ENGINE - FUEL AND CONTROL - INTRODUCTION OF A NEW FUEL DIVERTER AND RETURN VALVE WITH
NEW MICROSWITCH ASSEMBLIES - CATEGORY CODE 6 - MOD.ENG-73-0081

V2500-ENG-73-0081

No: 13298-73-006

No: 17300-73-006

Location of Microswitch Assembly
Figure 1

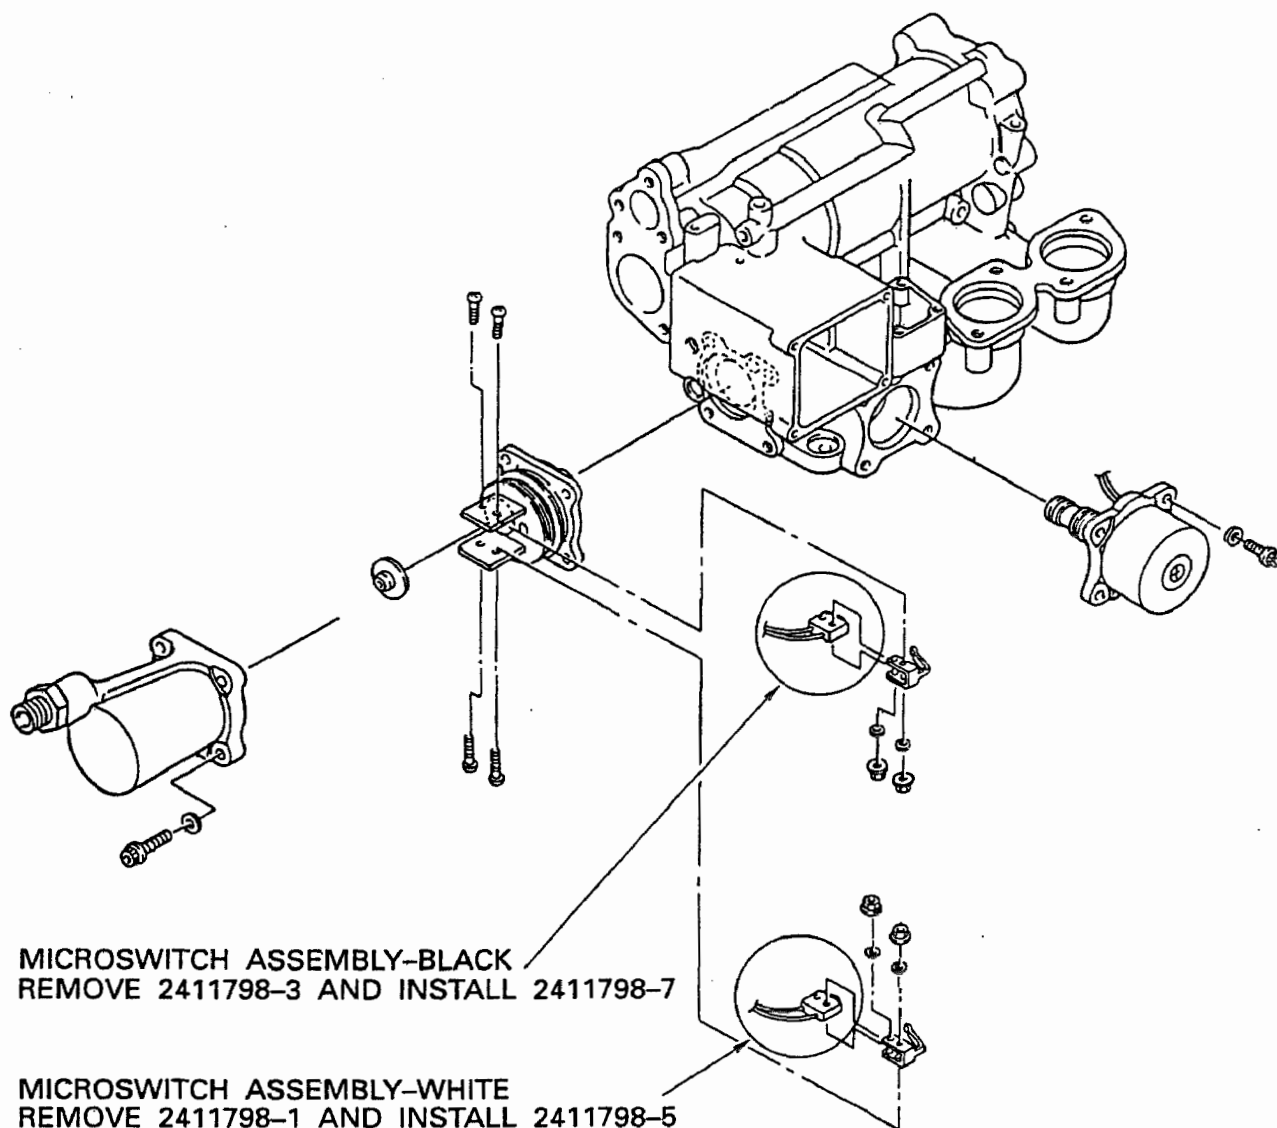
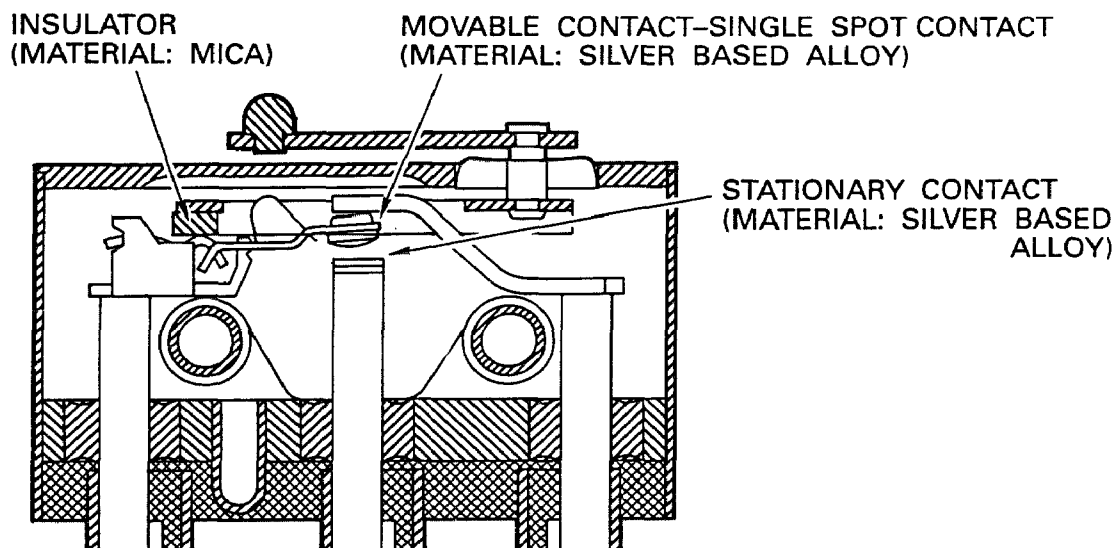
- (2) Existing FD&RV can be reworked by replacing the existing Microswitches with the new ones.
- (3) New Microswitches will be available for replacement purposes.
- (4) This Service Bulletin is comprised of the following two parts:

Specification Difference between the existing and the new Microswitches
Figure 2

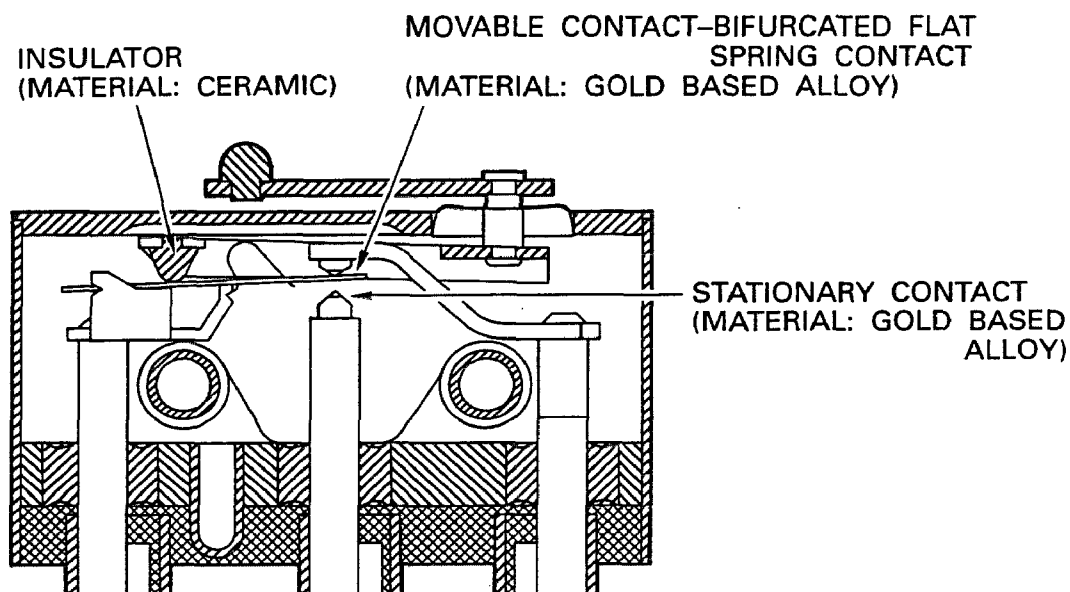
- (1) The changes introduced by this Service Bulletin are as follows: (Refer to Figure 2)

- a) The Movable Contact in the Microswitch is changed from the single spot contact to the bifurcated flat spring contact.
- b) The contact material in Microswitch is changed from silver based alloy to gold based alloy.
- c) The insulator material in Microswitch is changed from mica to ceramic.

Existing Microswitch (Part No. 2411798-1 or 2411798-3/Type: 6HM1-1)

New Microswitch (Part No. 2411798-5 or 2411798-7/Type: 20HM1-1)

Reidentification of Fuel Diverter and Return Valve
Figure 3

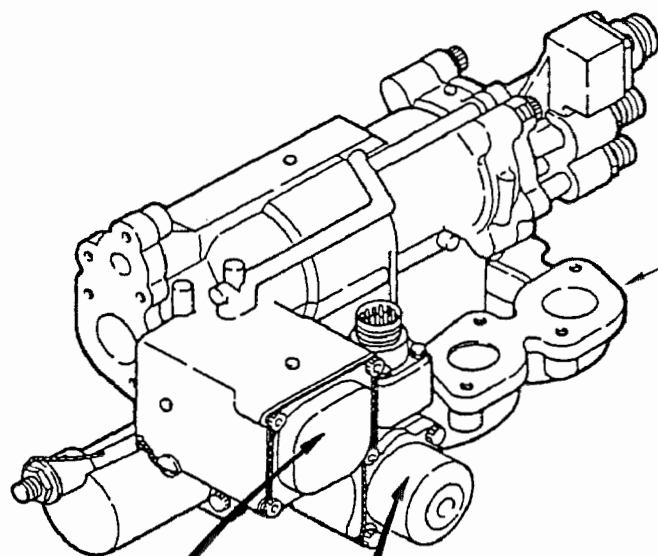
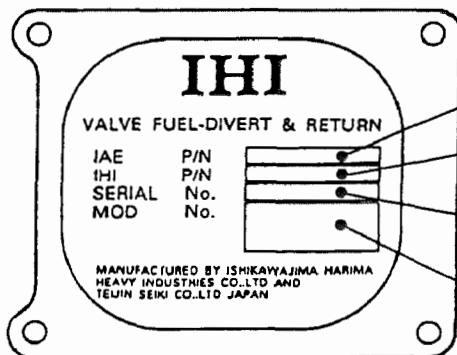
- (a) Assemble the new 2411798-5, Microswitch Assembly-White and the new 2411798-7, Microswitch Assembly-Black to the existing 2411700-25, Fuel Diverter Valve Assembly in accordance with the approved procedures in 1.L.Reference (3), Assembly.
- (b) Make marks of the new identification numbers on the new name plates with the metal stamps by hand press in accordance with the approved procedures in 1.L.Reference (4), 70-09-00 Markings of Part as follows: (Refer to Figure 3)

- (a) Assemble the new 2411798-5, Microswitch Assembly-White and the new 2411798-7, Microswitch Assembly-Black to the existing 2411700-29, Fuel Diverter Valve Assembly by the approved procedures in 1.L.Reference (3), Assembly.
- (b) Make marks of the new identification numbers on the new name plates with the metal stamps by hand press by the approved procedures in 1.L.Reference (4), 70-09-00 Markings of Part as follows: (Refer to Figure 3)

MAKE A MARK THE NEW PN 2411700-33 OR 2411700-37
WITH METAL STAMPS BY HAND PRESS.

MAKE A MARK THE NEW PN 5L0073 OR 5L0075
WITH METAL STAMPS BY HAND PRESS.

MAKE A MARK THE NEW
PN 13298G15 OR 13298G16
WITH METAL STAMPS BY HAND PRESS.

REMOVE AND DISCARD OLD PLATE AND
INSTALL THE NEW PN 13713P1 NAME PLATE (1 off)

Location of Microswitch Assembly
Figure 1

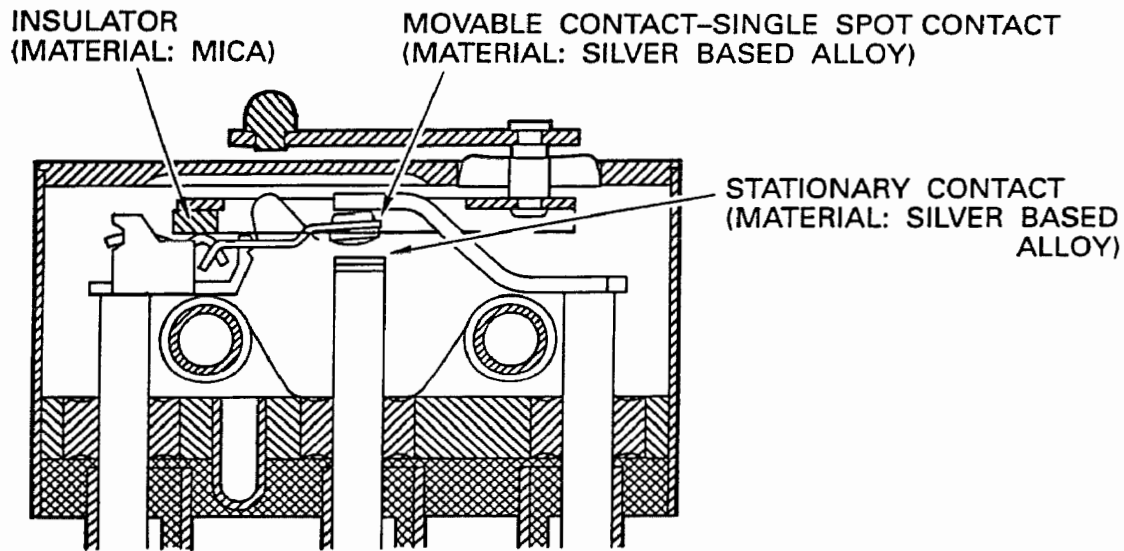
(2) Existing FD&RV can be reworked by replacing the existing Microswitches with the new ones.

Specification Difference between the existing and the new Microswitches
Figure 2

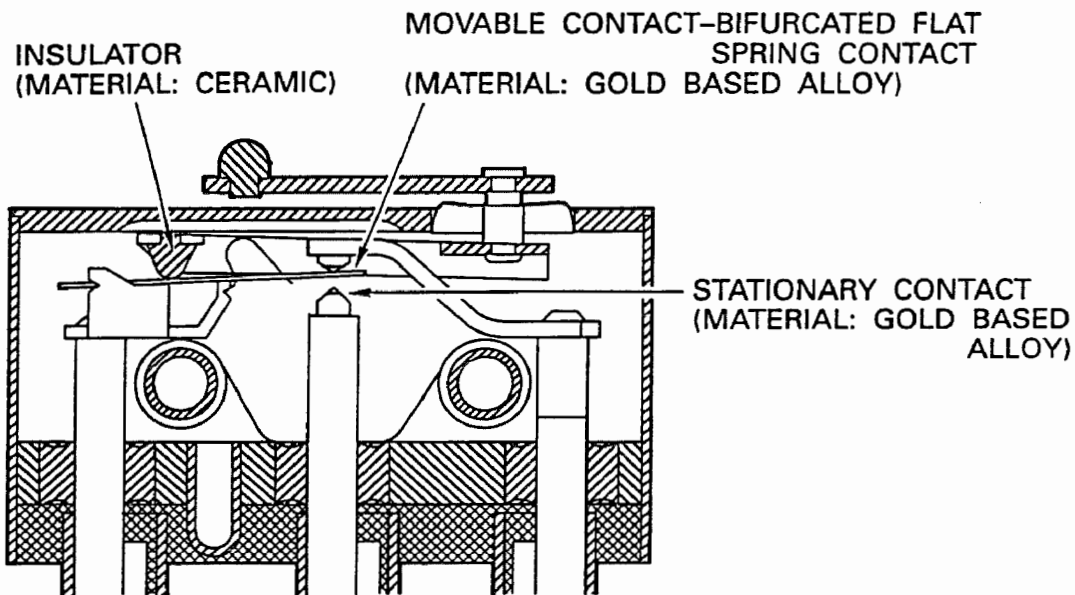
(1) The changes introduced by this Service Bulletin are as follows: (Refer to Figure 2)

- a) The Movable Contact in Microswitch is changed from the single spot contact to the bifurcated flat spring contact.
- b) The contact material in Microswitch is changed from silver based alloy to gold based alloy.
- c) The insulator material in Microswitch is changed from mica to ceramic.

Existing Microswitch (Part No. 2411798-1 or 2411798-3/Type: 6HM1-1)

New Microswitch (Part No. 2411798-5 or 2411798-7/Type: 20HM1-1)

Reidentification of Fuel Divertor and Return Valve
Figure 3

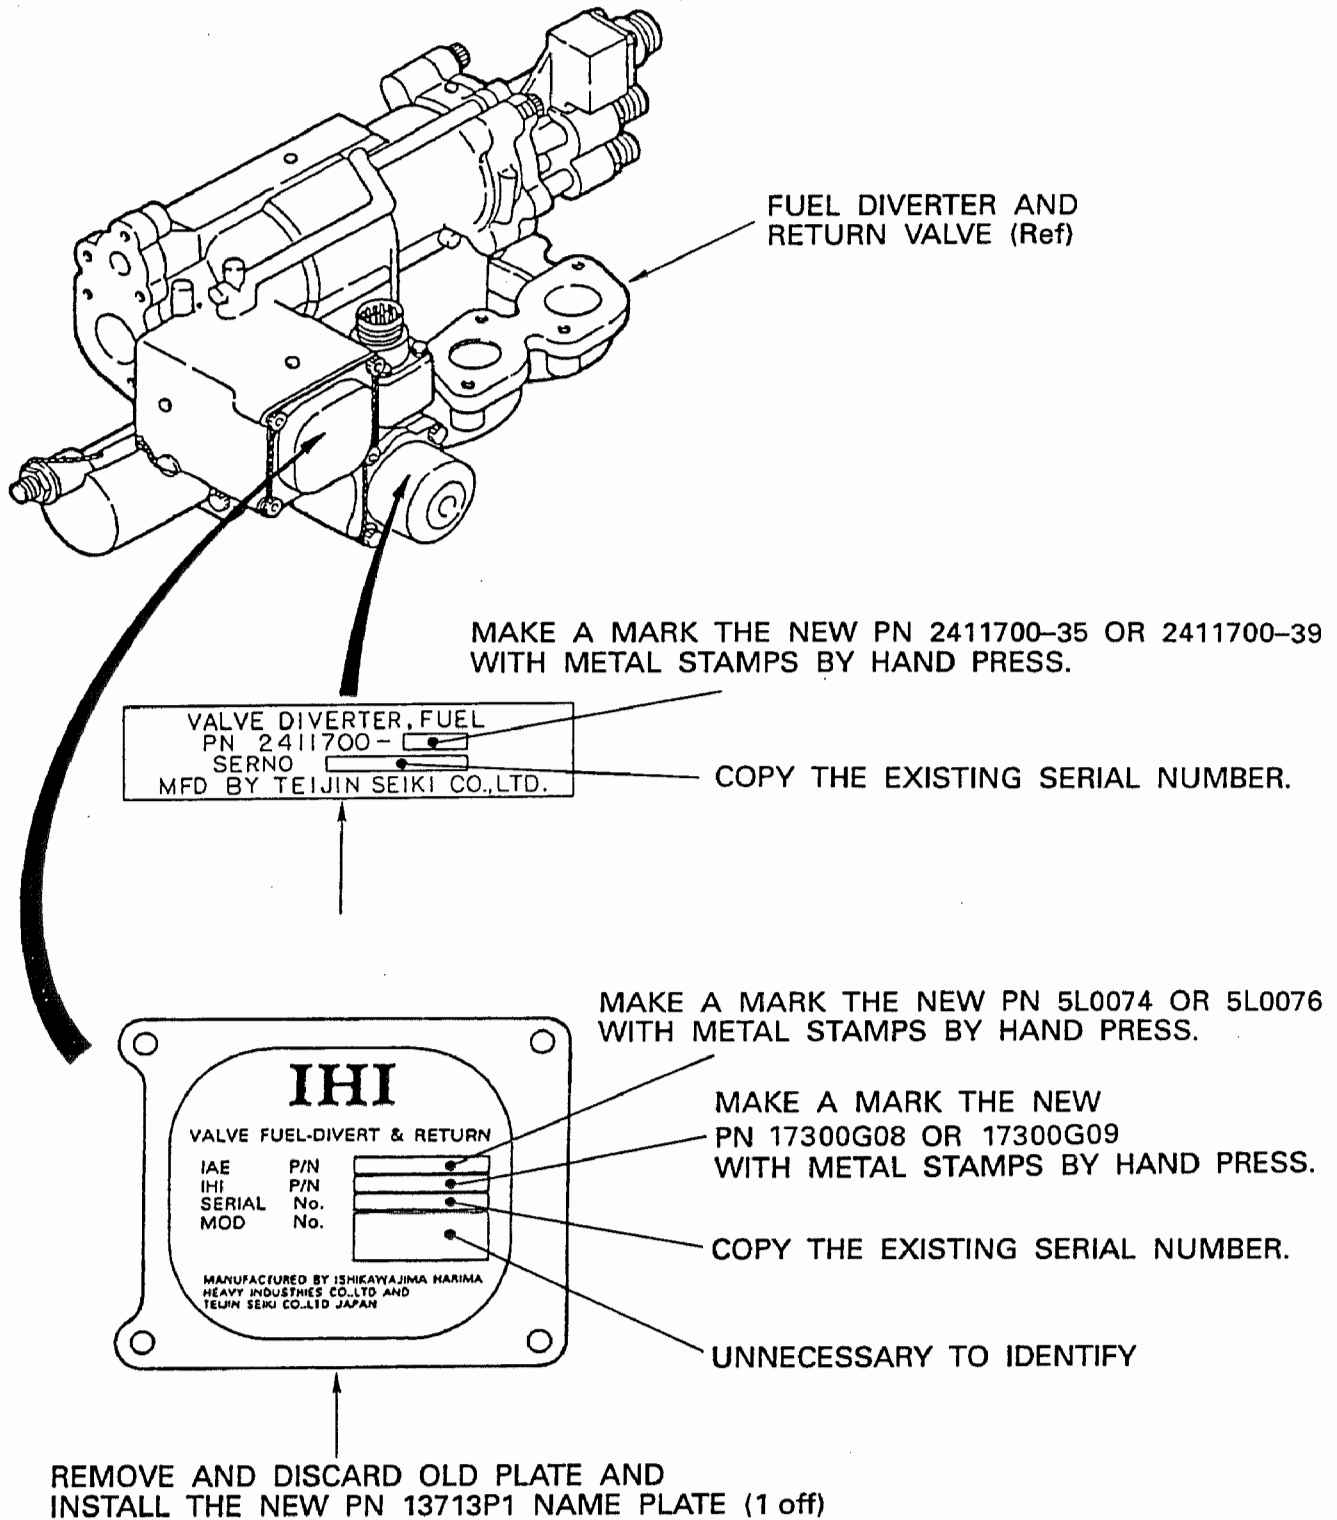
- (a) Assemble the new 2411798-5, Microswitch Assembly-White and the new 2411798-7, Microswitch Assembly-Black to the existing 2411700-27, Fuel Diverter Valve Assembly in accordance with the approved procedures in 1.L.Reference (3), Assembly.
- (b) Make marks of the new identification numbers on the new name plates with the metal stamps by hand press in accordance with the approved procedures in 1.L.Reference (4), 70-09-00 Markings of Part as follows: (Refer to Figure 3)

- (a) Assemble the new 2411798-5, Microswitch Assembly-White and the new 2411798-7, Microswitch Assembly-Black to the existing 2411700-31, Fuel Diverter Valve Assembly by the approved procedures in 1.L.Reference (3), Assembly.
- (b) Make marks of the new identification numbers on the new name plates with the metal stamps by hand press by the approved procedures in 1.L.Reference (4), 70-09-00 Markings of Part as follows: (Refer to Figure 3)
